# Access Compliance Report

## Public Rights-of-Way

### (Curb Ramps)

Intersection ID: 6475	Main Street: CAPPS_HILL_MINE_RD	Cross Street: FIRESTONE_DR	Location: S
ADA ID: E28D9F9F5FDB	Ramp Type: Perp	Initial Pass/Fail: Fail	Overall Compliance: No
Codes/Mitigation Info/Possible Solution		Field Measurements/Component Compliance	
Severity Score: 21.25

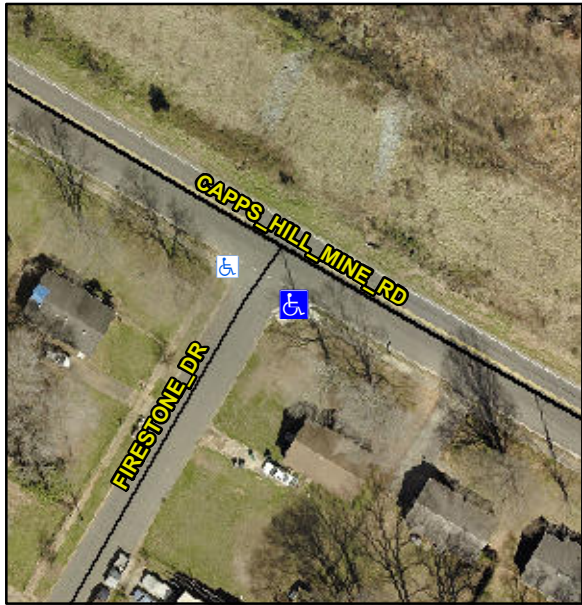
Not Found, R304.5.1, R304.2.2

Compliance		Description	Data	Compliance	Description	Data
N/A	Ramp Length (in)	49.0	No	Ramp Slope (%)	9.7	
No	Ramp Width (in)	46.5	Yes	Ramp XSlope (%)	2.0	
N/A	Flare Type LT	N/A	N/A	Flare Type RT	N/A	
N/A	Flare Slope LT (%)	N/A	N/A	Flare Slope RT (%)	N/A	
N/A	Flare Traversable LT?	N/A	N/A	Flare Traversable RT?	N/A	
N/A	Landing Length (in)	N/A	N/A	DWS Provided?	N/A	
N/A	Landing Width (in)	N/A	N/A	DWS Contrast?	N/A	
N/A	Landing Slope (%)	N/A	N/A	DWS Length (in)	N/A	
N/A	Landing X Slope (%)	N/A	N/A	DWS Full Width?	N/A	
N/A	Landing Curb? (Y/N)	N/A	N/A	DWS Offset (in)	N/A	
N/A	Shared Landing?	N/A				
N/A	Gutter Ponding?	N/A	N/A	Gutter Slope (%)	N/A	
N/A	Gutter Lip Ht (in)	2.0	N/A	Gutter X Slope (%)	N/A	
N/A	Painted X Walk1?	No	N/A	Painted X Walk2?	N/A	
	X Walk 1 Direction	To NW		X Walk 2 Direction	N/A	
N/A	X Walk 1 Width (in)	N/A	N/A	X Walk 2 Width (in)	N/A	
	X Walk 1 Slope (%)	1.3		X Walk 2 Slope (%)	N/A	
	X Walk 1 X Slope (%)	1.4		X Walk 2 X Slope (%)	N/A

Remove & Replace Entire Ramp.
